L-2011-100  
10 CFR 50.90

Re: Turkey Point Units 3 and 4  
Docket Nos. 50-250 and 50-251  
Response to NRC Request for Additional Information Regarding  
Extended Power Uprate License Amendment Request No. 205 and Nuclear  
Performance and Code Review Issues

**RESPONSE TO NRC RAI REGARDING EPU LAR NO. 205  
AND NUCLEAR PERFORMANCE AND CODE REVIEW**

**Figure 1.3-3 Core Directions used in the Seismic/LOCA Analysis  
(Example: Mixed Core of 15x15 Upgrade Fuel  
and 15x15 DRFA Fuel)**

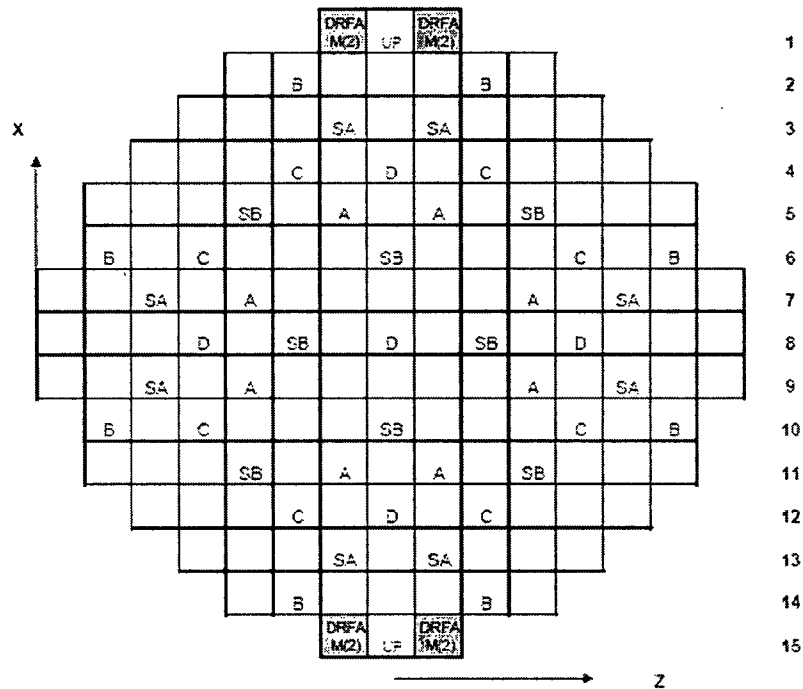
**SNPB-1.3      Section 2.8.1.2.3 Seismic/LOCA: (a) Justify that the structural loading methodologies including the WEGAP code are applicable for the Upgrade fuel assembly design of 15x15 array; (b) Describe of the two limiting mixed cores of DRFA and Upgrade fuel assemblies; (c) Elaborate how the leak-before-break methodology is used for the reactor coolant loop piping, (d) Provide details how the maximum structural loads occurs at the outer three assembly rows on the core periphery for the Upgrade fuel at non-RCCA locations; and (e) Provide details how the maximum fuel assembly deflection occurs in an assembly row consisting of 9, 11, 13, and 15 fuel assemblies in the Z-direction during a LOCA ACC loading.**

This table shows that the “3 FA row” is more limiting than the other rows within the core and that some amount of grid crush is predicted. As shown by Figure 1.3-3, the grid crush was evaluated for both the “X” and “Z” lateral directions. Also, as shown by Figure 1.3-3, there are no Rod Control Cluster Assemblies (RCCAs) in the 3 FA row (control rod locations are indicated by the “A”, “B”, “C” and “D” core locations, shutdown banks are indicated by the “SA” and “SB” core locations). It is also important to note that the analysis conservatively assumes that the RCCAs are full withdrawn and not inserted into any of the fuel assemblies. The presence of RCCAs in the fuel assemblies would tend to dampen the effects of the LOCA and/or seismic event, although this is a very small effect.

(e) The “X” and “Z” directions are defined as shown by Figure 1.3-3. The basis for why one direction may be more limiting than another is primarily the result of the location of the LOCA break relative to the fuel assemblies in the core. An examination of the core plate motions for both the “X” and “Z” directions shows that the core plate motions in the “Z” direction are significantly greater than for the “X” direction, thus, the more limiting results for the maximum fuel assembly deflection is in the “Z” direction for the different fuel assembly rows, that is, 9, 11, 13 and 15 FA rows. Table 1.3-2 presents the results for the different fuel rows for the “Z” direction during a LOCA due to accumulator line break in the cold leg (ACC) loading.
